# UNITED STATES PATENT AND TRADEMARK OFFICE

APPLICATION NO.	FILING DATE	FIRST NAMED INVENTOR	ATTORNEY DOCKET NO.	CONFIRMATION NO.
10/598,893	09/14/2006	Kengo Onaka	36856.1463	1786

<b>Office Action Summary</b>	<b>Application No.</b> 10/598,893	<b>Applicant(s)</b> ONAKA ET AL.	
	<b>Examiner</b> Trinh Vo Dinh	<b>Art Unit</b> 2821

### DETAILED ACTION

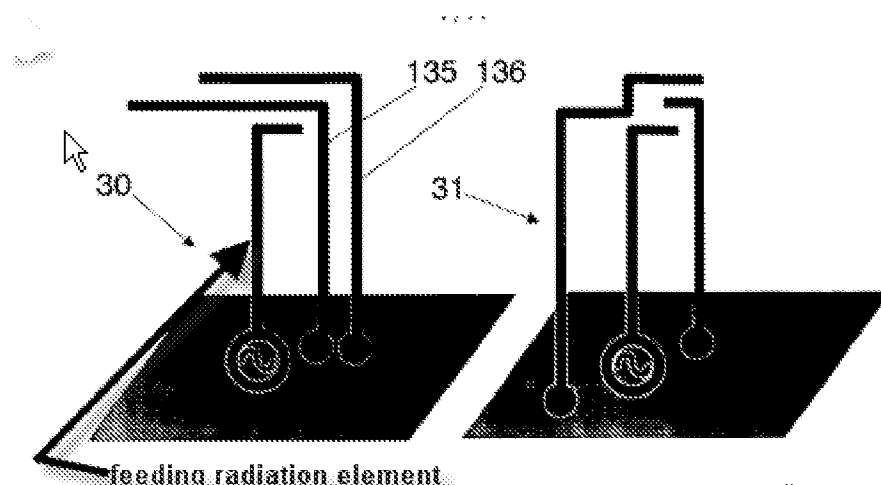
Respecting claim 13, PUENTE discloses, in Fig. 7, an antenna (30) comprising a substrate (p. 14, lines 3-4) having a ground electrode, a feeding radiation element (in an above Figure) including feeding means and including a radiation electrode outside a dielectric, and a first non-feeding radiation element (136) including a radiation electrode outside a dielectric substance, a second non-feeding radiation element (135) including a radiation electrode outside a dielectric substance wherein the first non-feeding radiation element (136) and the second non-feeding radiation element (135) are electrically connected to the ground electrode (p. 13, line 9), wherein the feeding radiation element is disposed on the ground electrode such that a surface of the radiation electrode of the feeding radiation element is substantially parallel to a face of the ground electrode and such that the feeding radiation element is disposed in the vicinity of a predetermined side of four peripheral sides of the ground electrode (i.e. at the left-hand side antenna 30). PUENTE further discloses the first nonfeeding radiation element (136) is disposed on the ground electrode such that a face of the radiation electrode (i.e. a horizontal part of electrode 136 being connected the vertical part) is substantially parallel to the face of the ground electrode and such that the first non-feeding radiation element (136) is disposed in the vicinity of the predetermined side wherein the second nonfeeding radiation element (135) is disposed such that the second nonfeeding radiation element (135) is adjacent to both the feeding radiation element and the first non-feeding radiation element (136) and such that at least part of the second nonfeeding radiation element (135) projects outside the ground electrode from the predetermined side (i.e. one end of the element 135 projects partly outside the left hand side of the ground electrode of antenna 30, as depicted in Fig. 7).

Respecting claims 14-16 and 19, PUENTE further discloses the dielectric substance being defined by a single base member (Fig. 7), or being defined by at least two separate dielectric base members (Fig. 14), the second non-feeding radiation element (135) is electrically connected at a substantially central location of the desired side, of the ground electrode, and the ground electrode is defined by a conductor pattern that is provided on the substrate and that has a substantially rectangular shape (Fig. 7) when viewed in plan.

Respecting claims 20 and 27, PUENTE discloses, in Fig. 7) the dielectric substance (p. 14, lines 3-4) being defined by a dielectric base member, and the radiation electrode of each of the feeding radiation element, the first non-feeding radiation element (136), and the second non-feeding radiation element (135) is provided on the dielectric base member. Furthermore, PUENTE discloses a portable radio communication apparatus comprising the antenna (page 8, lines 17-19).
